**Item No. 9.1.1**  
**Design Review Committee**  
**March 8, 2018**

**SUBJECT:** **Case 21538: Substantive Site Plan Approval – 1505 Barrington Street,  
Halifax (Maritime Centre)**

Application by WSP Canada Inc. for substantive site plan approval to enable the development of an addition at the base of the Maritime Centre building at the northwest corner of Barrington Street and Salter Street.

Maritime Centre Redevelopment NORTH ELEVATION (SALTER STREET)

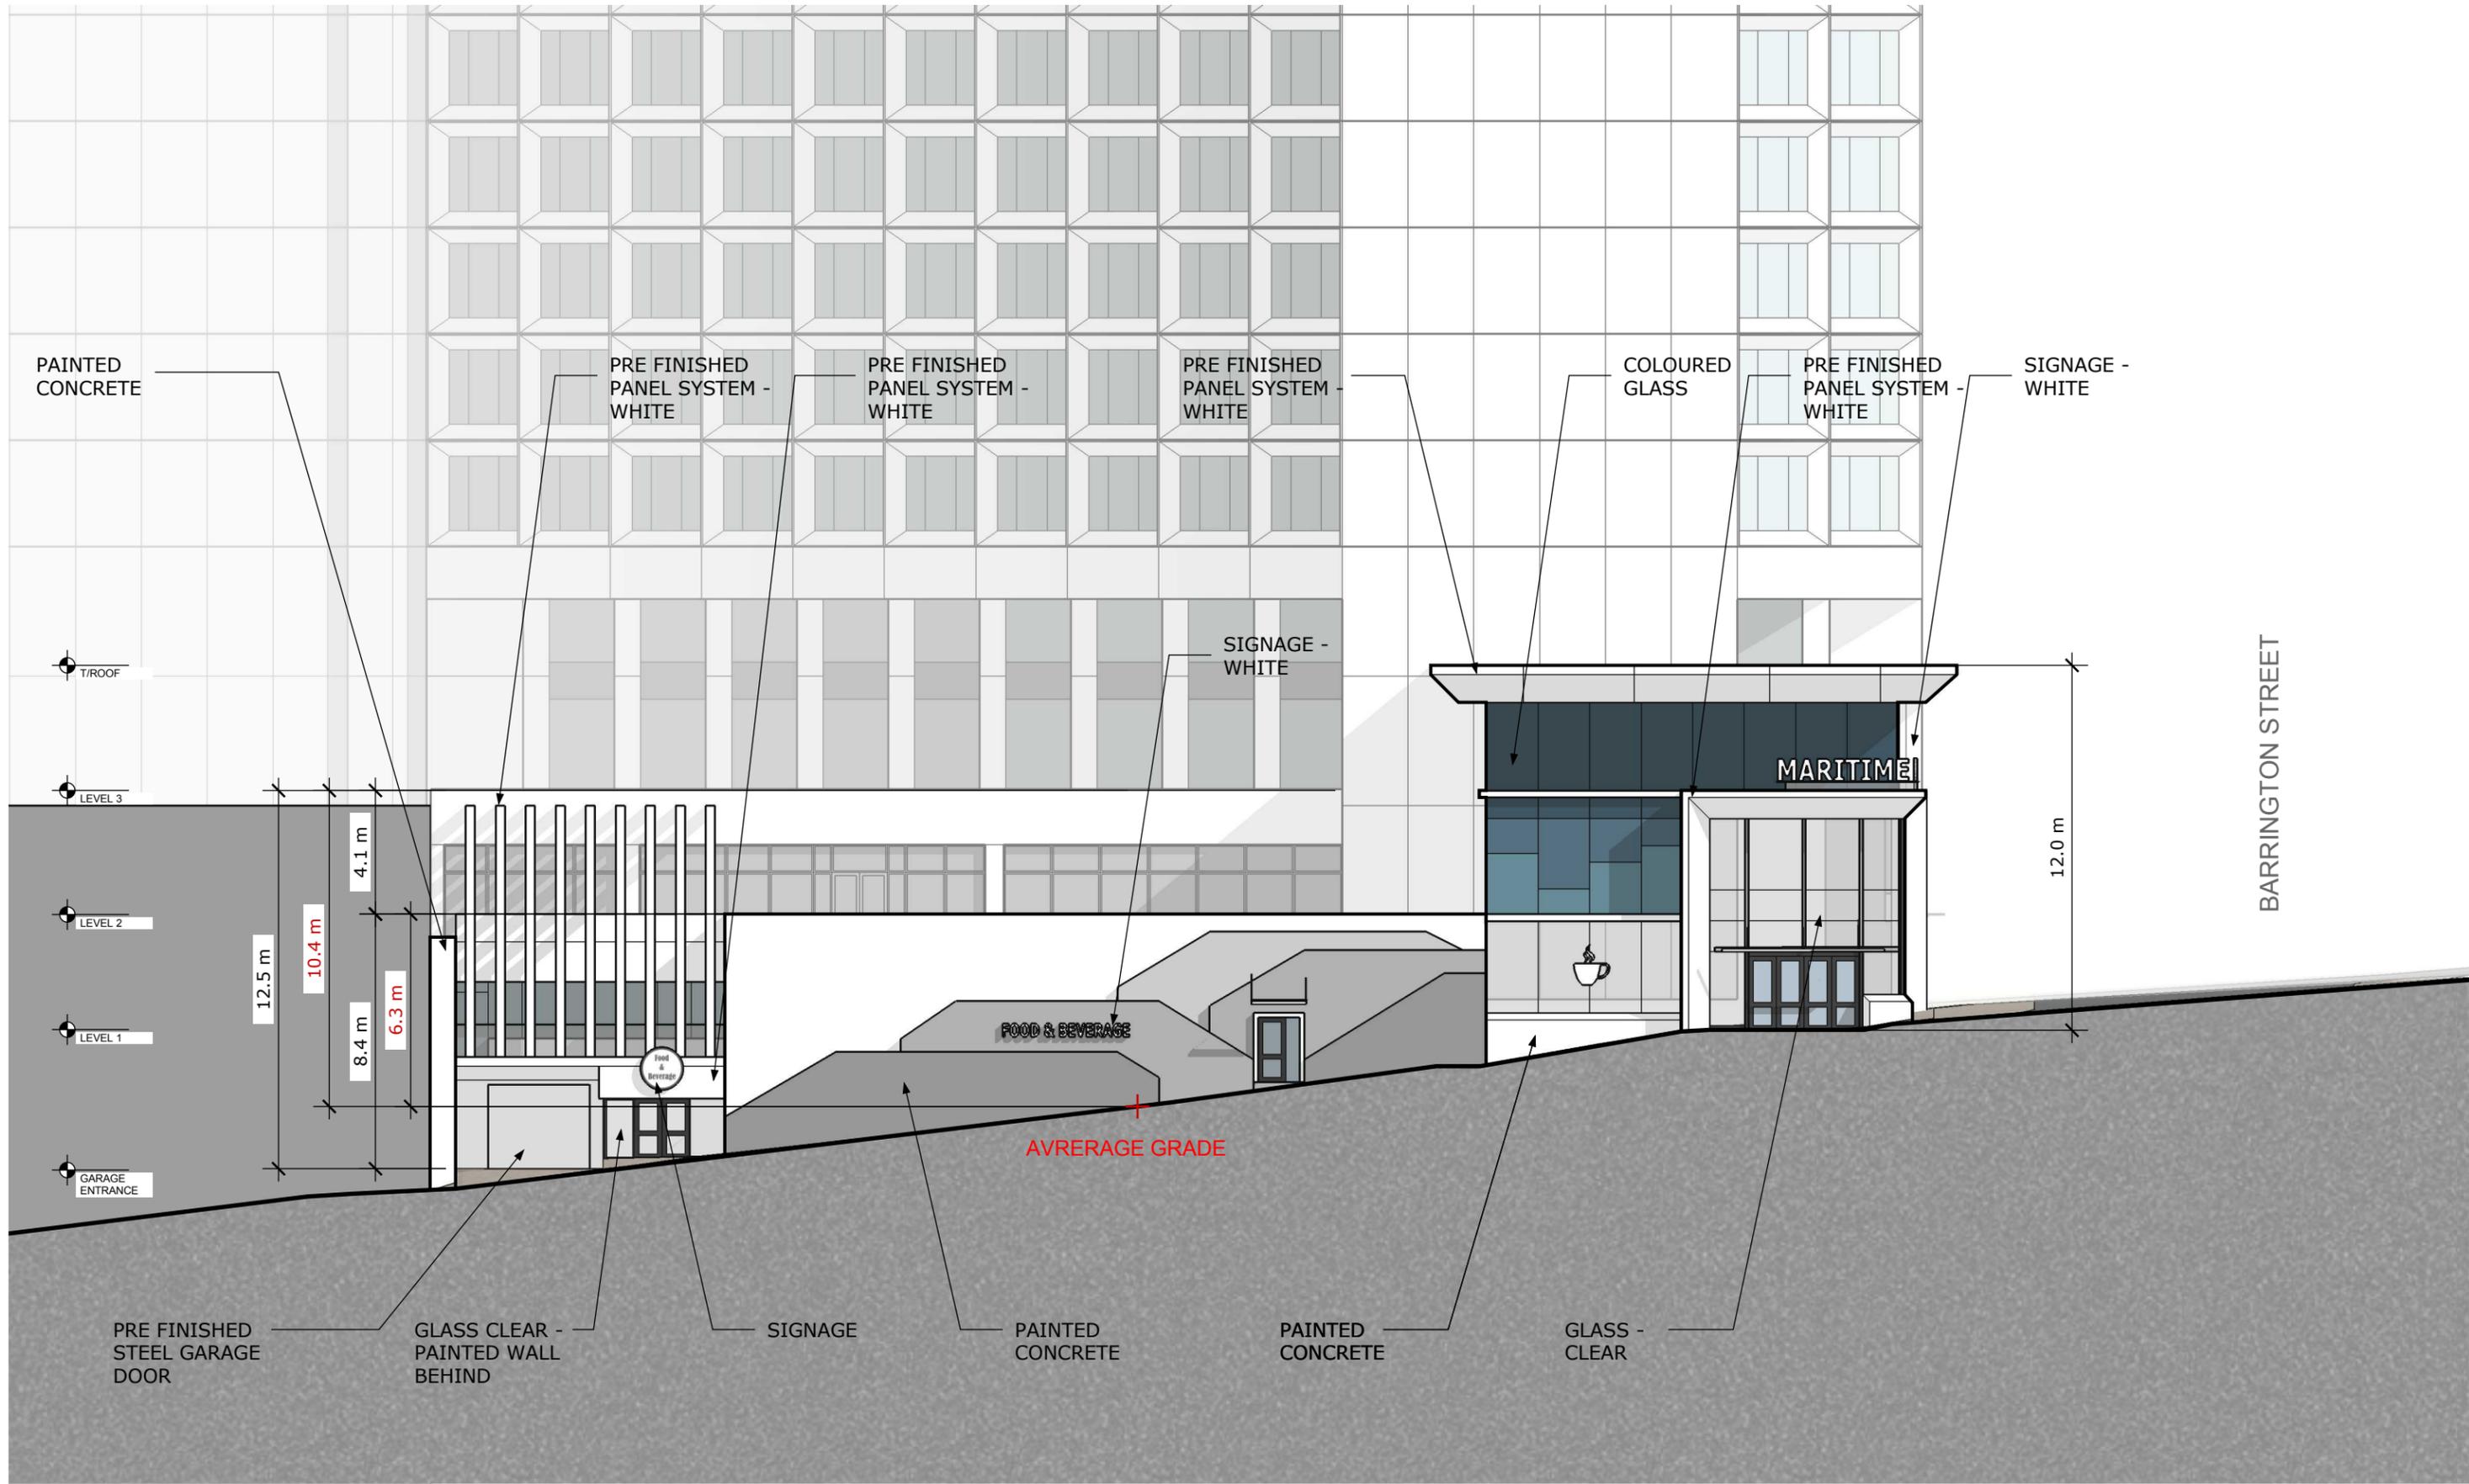
A new parking garage door (egress only) is proposed on Salter Street at a location that aligns with the southern end of the Granville Street visual terminus corridor. The Design Manual identifies this corridor as a prominent Visual Terminus Site and distinctive architectural treatment is required at this location. The applicant has provided a vertically slotted projection surmounting the garage door in response to this requirement (see Attachment A – Sheet A-304). Staff advise the proposed approach does not meet the Design Manual and is a lost opportunity for a signature or landmark architectural treatment/feature in this location. The Design Manual obligation for the highest possible design and material quality has not been met.

Staff recommend the garage door not be permitted at the proposed location unless additional architectural treatment is included to comply with Visual Terminus obligations in the Design Manual.

Staff advise that the project is generally consistent with the Design Manual; with the only exception being the proposed garage door at Salter Street that does not meet the guidelines respecting terminus of a view corridor. Staff therefore recommend that the Design Review Committee approve the substantive site plan approval application with the condition that the proposed garage door at Salter Street not be permitted unless additional distinctive architectural treatment is included to comply with Prominent Visual Terminus obligations of the Design Manual.
